**ADDENDUM NO. 1**

**TOWN OF BRIDGEWATER  
ELM STREET RECONSTRUCTION PROJECT**

**BIDDER QUESTIONS**

ELM STREET - STA 10+64± TO 52+00±  
STA 56+00± TO 66+25±  
NTS

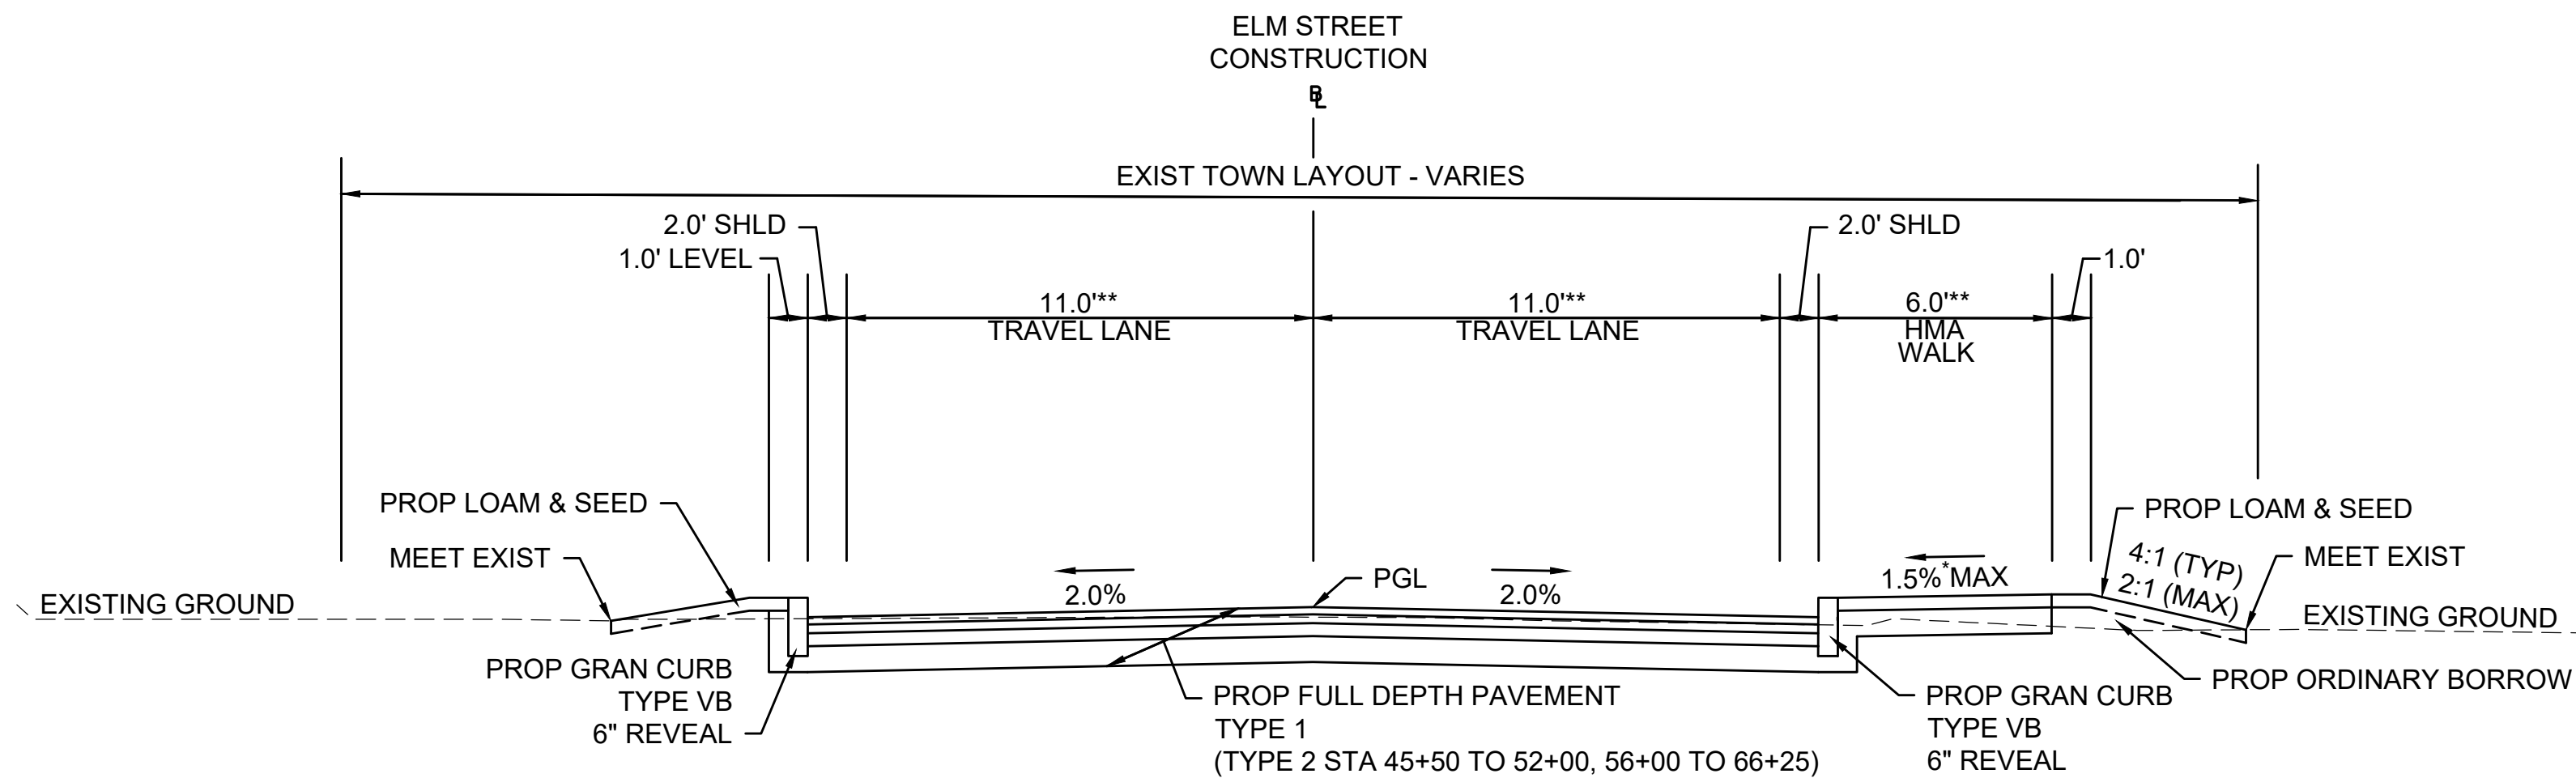
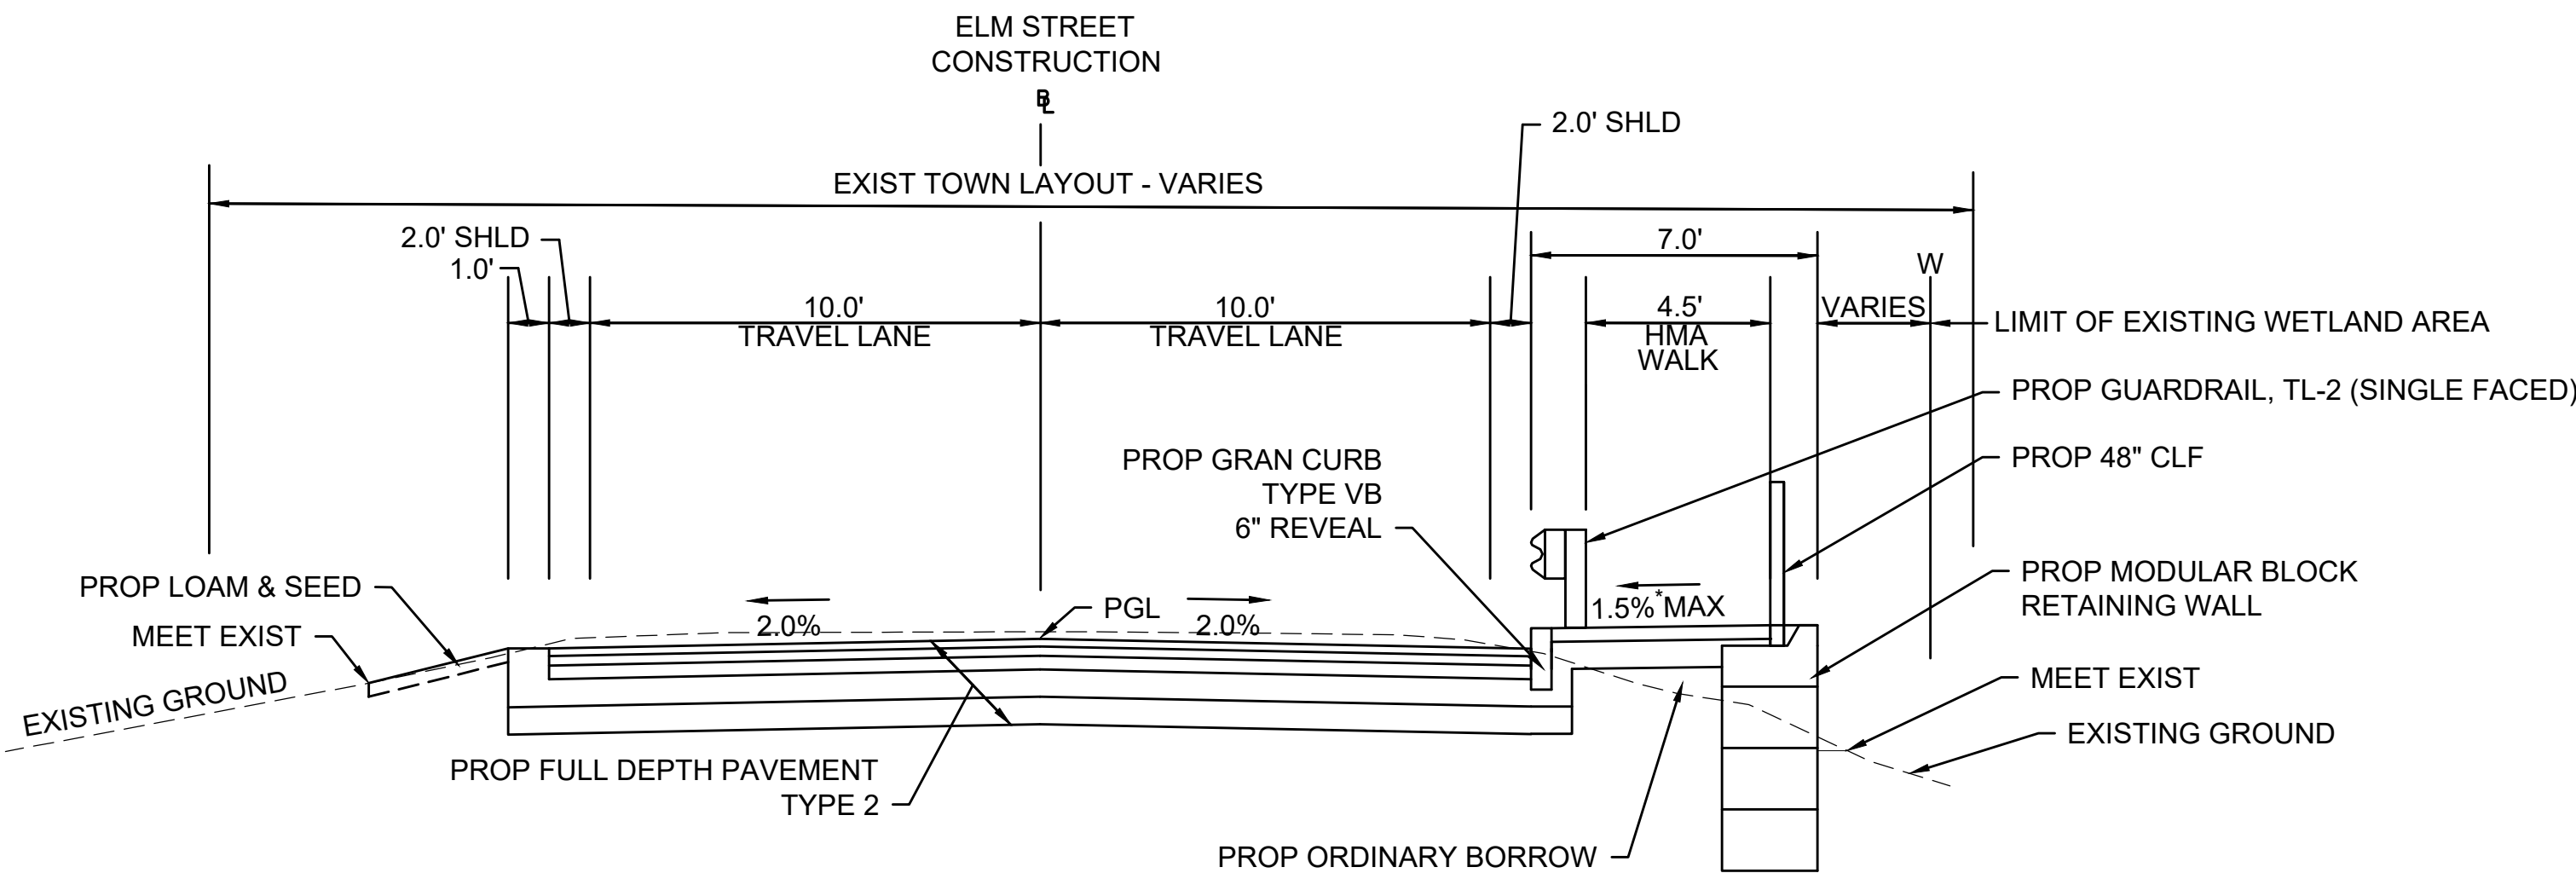
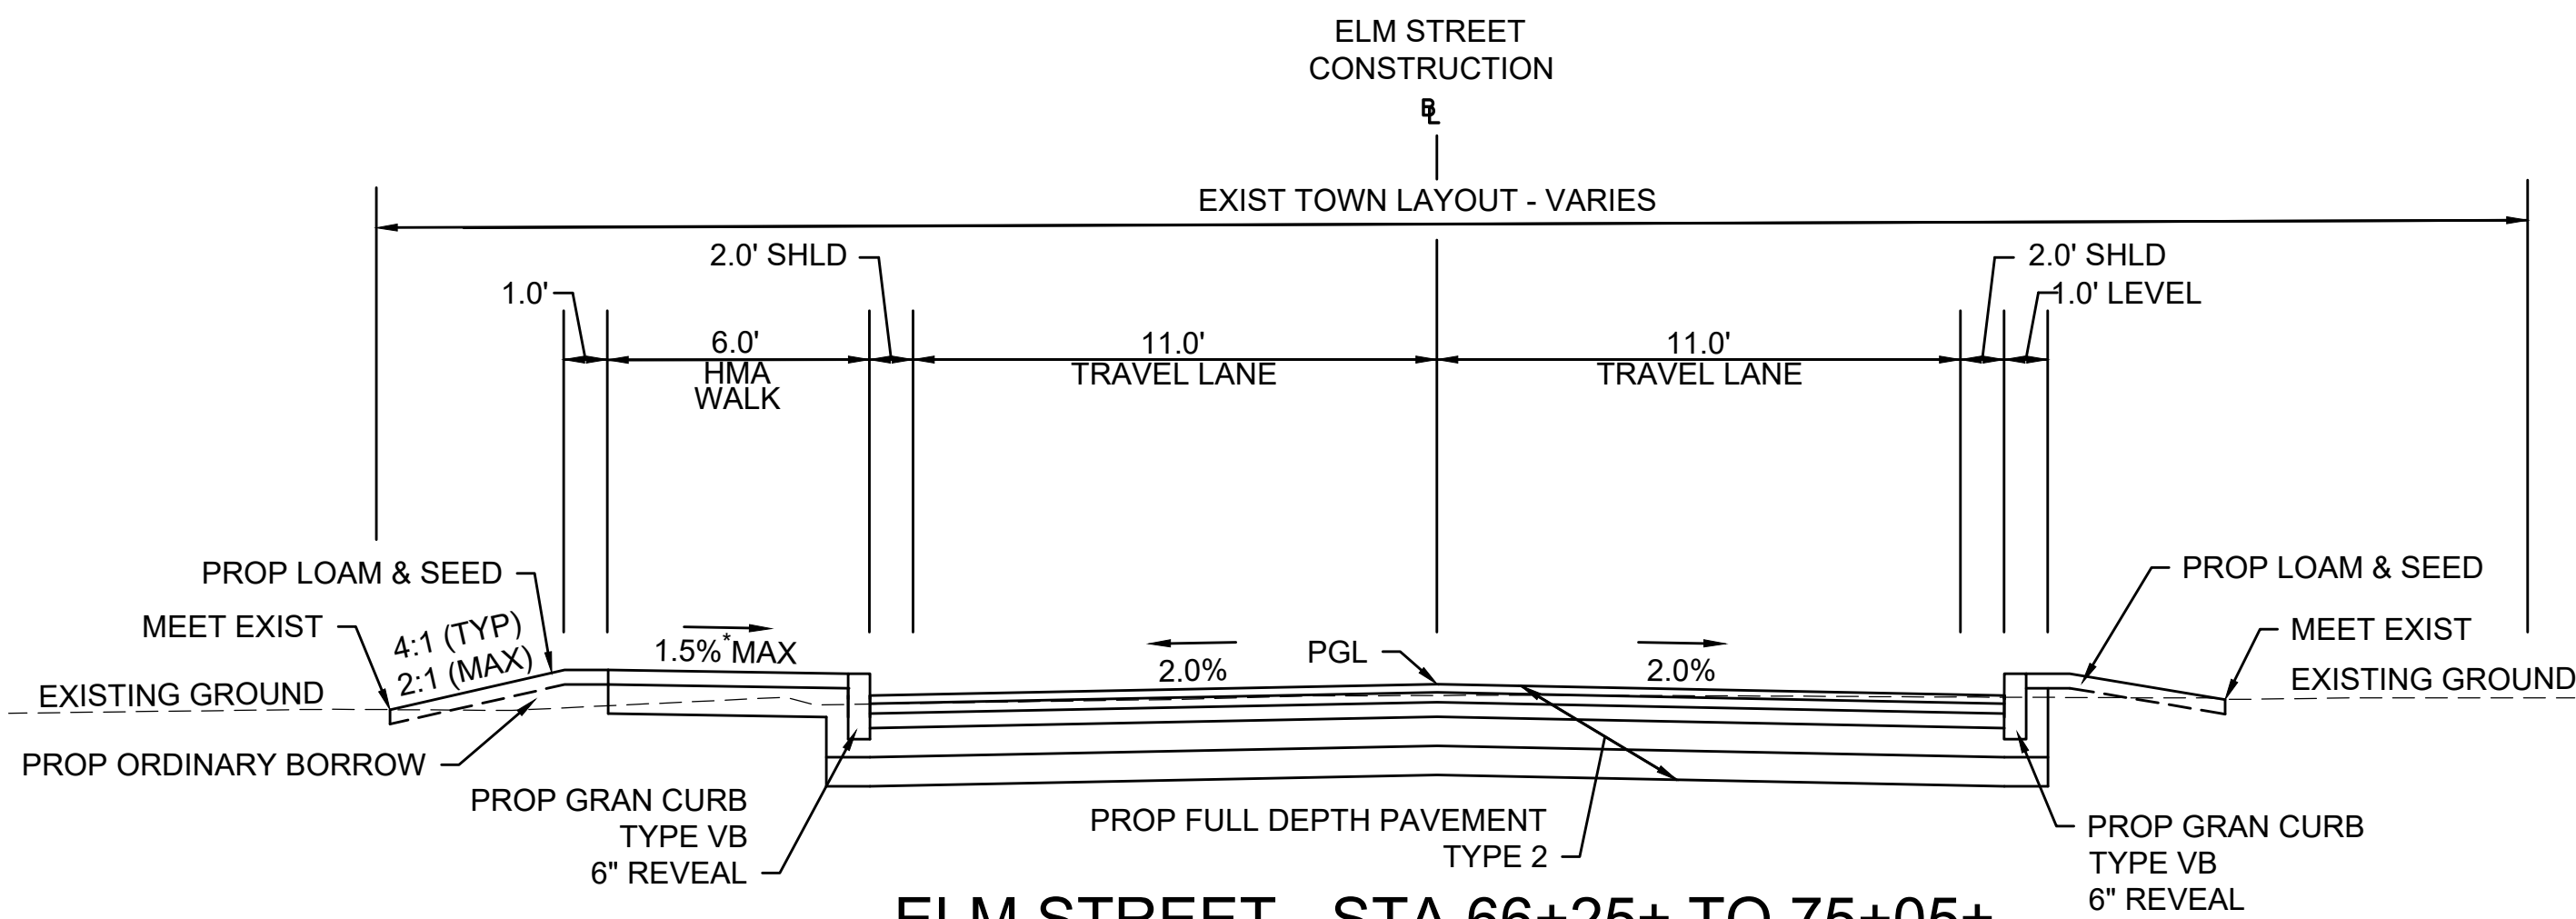
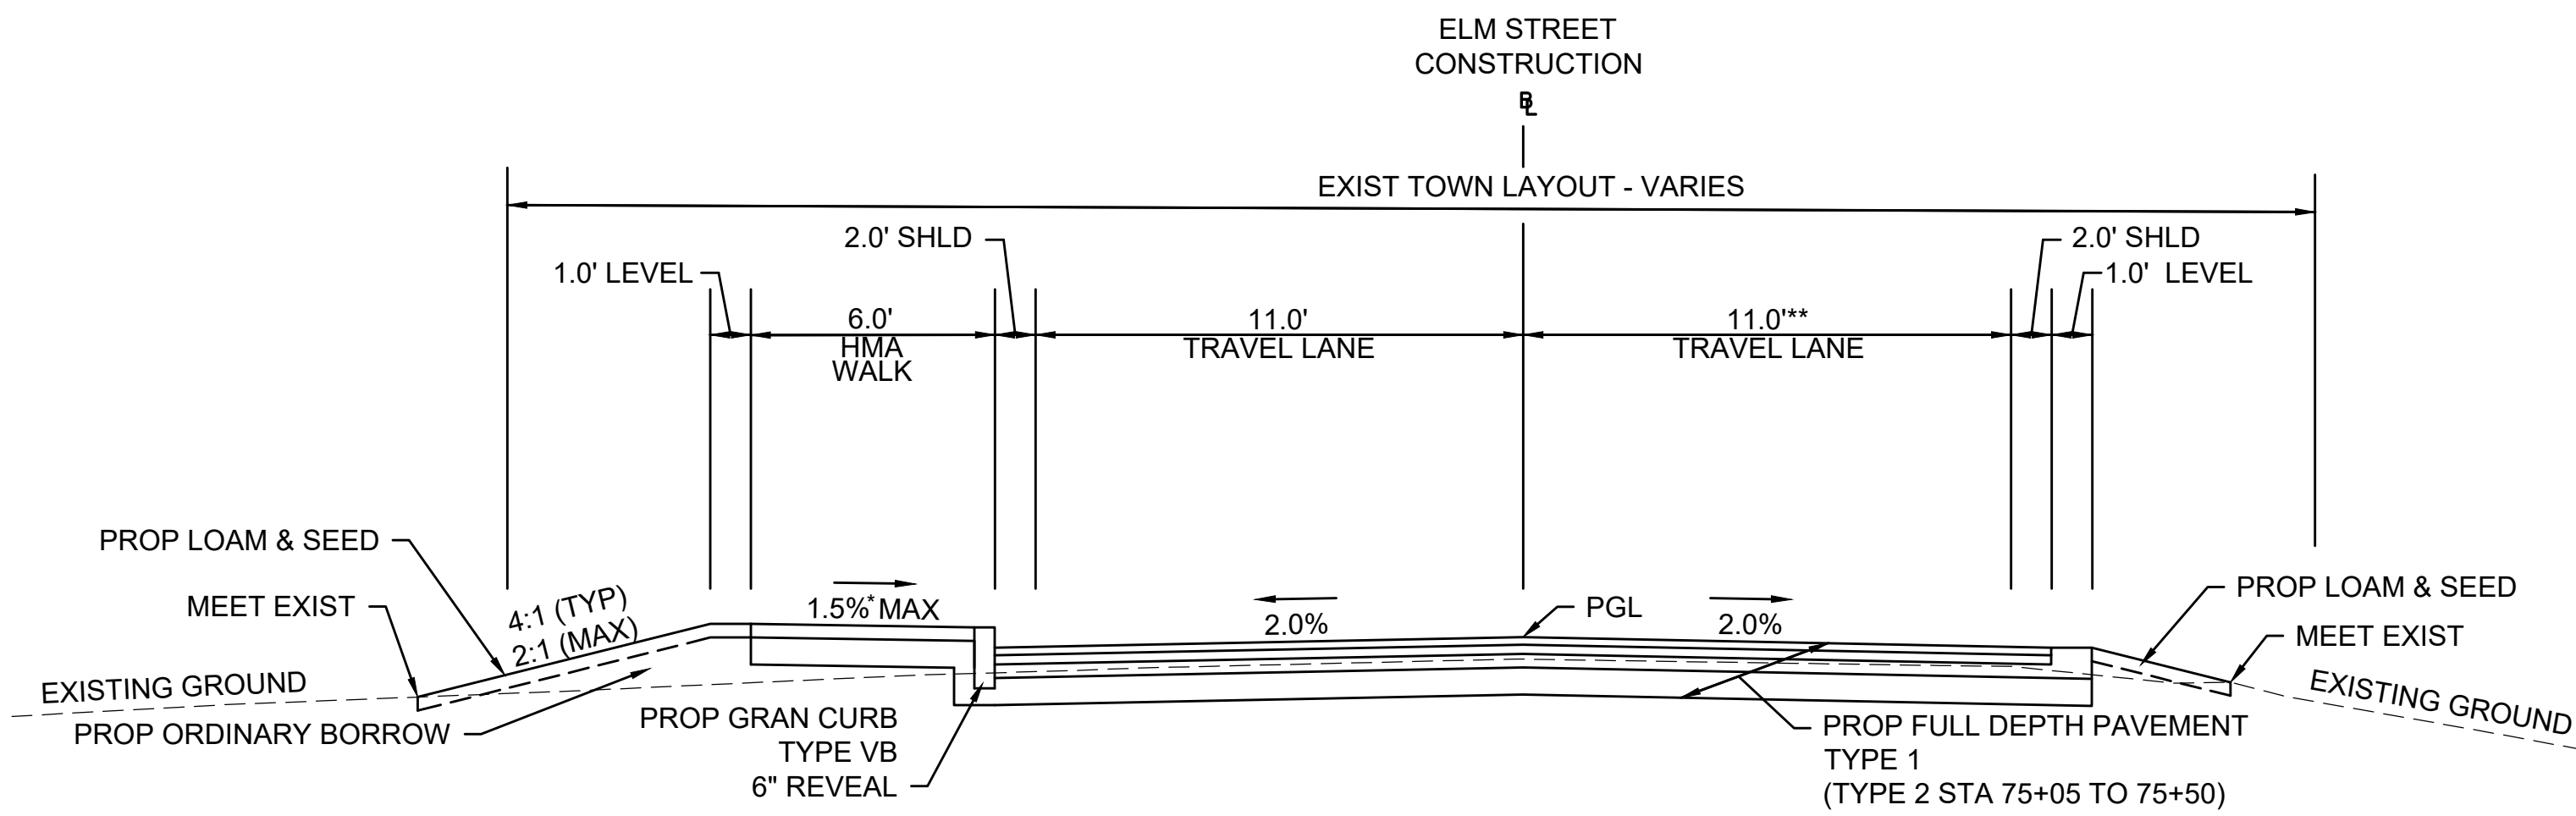
2. Drawing Sheet #2, Typical Road section show road construction from Station 10+64 to Station 92+50. Plans show construction to Station 95+00. Please confirm which detail/section is required for the work from Station 92+50 to 95+00 (or is this work not included in the project scope)?

**Answer: The section of Elm Street between Station 92+50 to 95+00 will be reconstructed (Full Depth Pavement Type 1). In general, this section of Elm Street has no proposed sidewalk and no roadway widening. The reconstruction is proposed to occur within the existing roadway footprint.**
